MFN 06-344

Docket No. 52-010

Subject: **Response to Portion of NRC Request for Additional Information
Letter No. 54 Related to ESBWR Design Certification Application –
Radioactive Waste Management – RAI Numbers 11.2-11, 11.2-12,
11.2-14, 11.3-1 and 11.3-3**

**Response to Portion of NRC Request for
Additional Information Letter No. 54
Related to ESBWR Design Certification Application
Radioactive Waste Management
RAI Numbers 11.2-11, 11.2-12, 11.2-14, 11.3-1 and 11.3-3**

Figure 11.2-2. Liquid Waste Management System Process Stream Information Directory

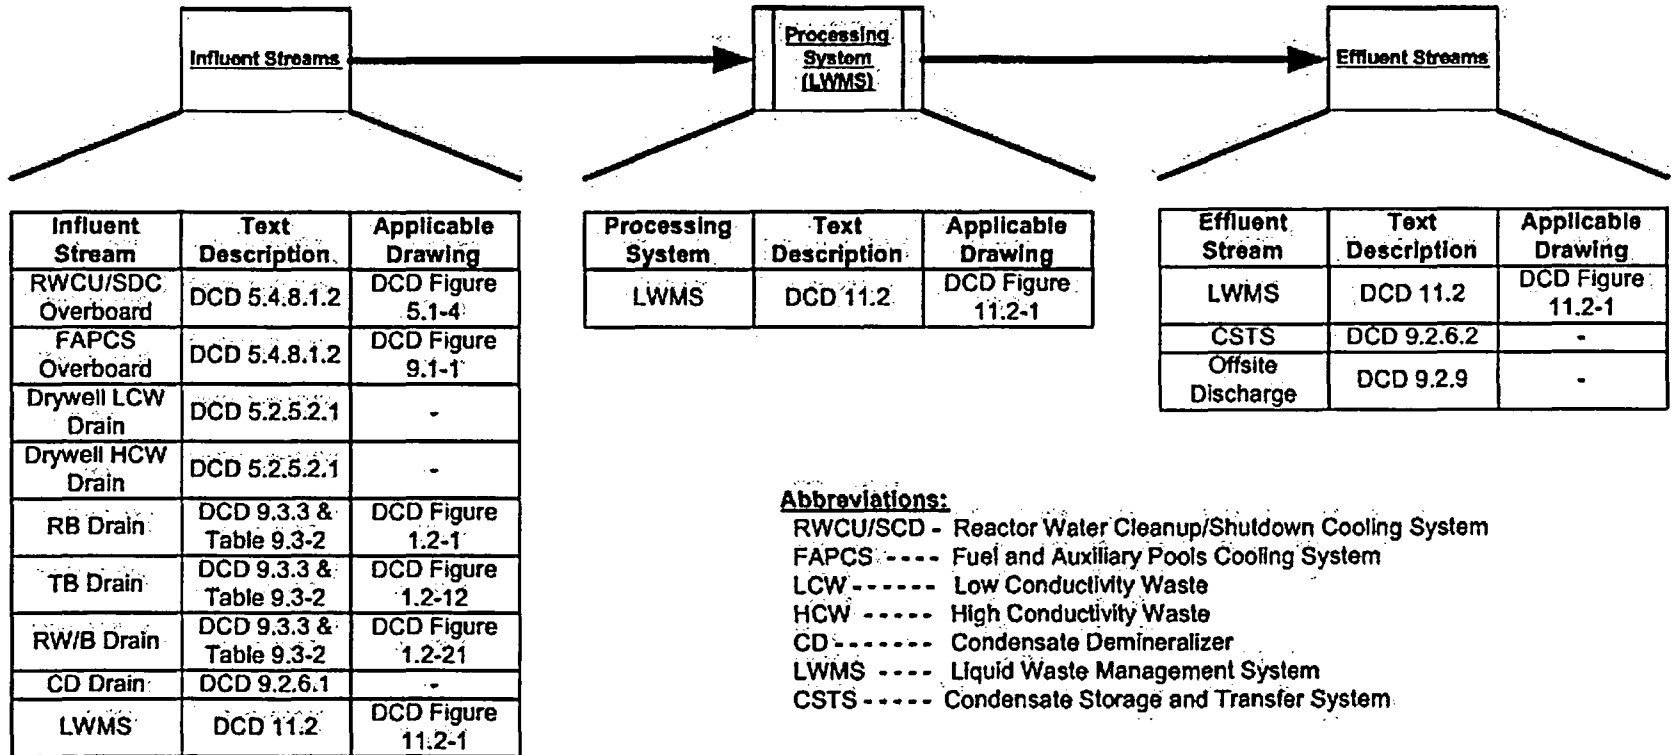
DCD Tier 2, Figure 11.2-1, "Liquid Waste Management System Process Diagram," does not provide sufficient detail to assess the system's adequacy. Locations of components relative to other plant components and buildings are not shown. Update the diagram to include sufficient detail to identify all sources of liquid input volumes (e.g., condensate storage tank collection berm and individual building sumps), the points of collection of liquid waste, the flow paths of liquids through the system including all bypasses, and the specific points of release of liquid effluents to the environment (e.g., interface COL item with circulating water system), consistent with the guidance of Standard Review Plan (SRP) Section 11.2, Rev. 2, July 1981, Review Criterion III.1.

DCD Tier 2 Chapter 11 will be revised to include a new Figure 11.2-2, "Liquid Waste Management System Process Stream Information Directory." Additionally, a description of Figure 11.2-2 has been added in Section 11.2. These attached improvements to the DCD are consistent with the guidance of Standard Review Plan (SRP) Section 11.2, Rev.2, July 1981, Review Criterion III.1.

A LWMS Process Diagram depicting all four subsystems is provided in Figure 11.2-1. A LWMS Process Stream Information Directory and simplified flow diagram is provided in Figure 11.2-2. A conceptual radwaste building general arrangement is provided in Figures 1.2-21 thru 1.2-25. The LWMS equipment codes and component capacities are provided in Tables 11.2-1, 11.2-2a, 11.2-2b, and 11.2-2c, respectively. The normal and maximum daily inputs, and process decontamination factors for the LWMS subsystems are provided in Tables 11.2-3 and 11.2-4, respectively.
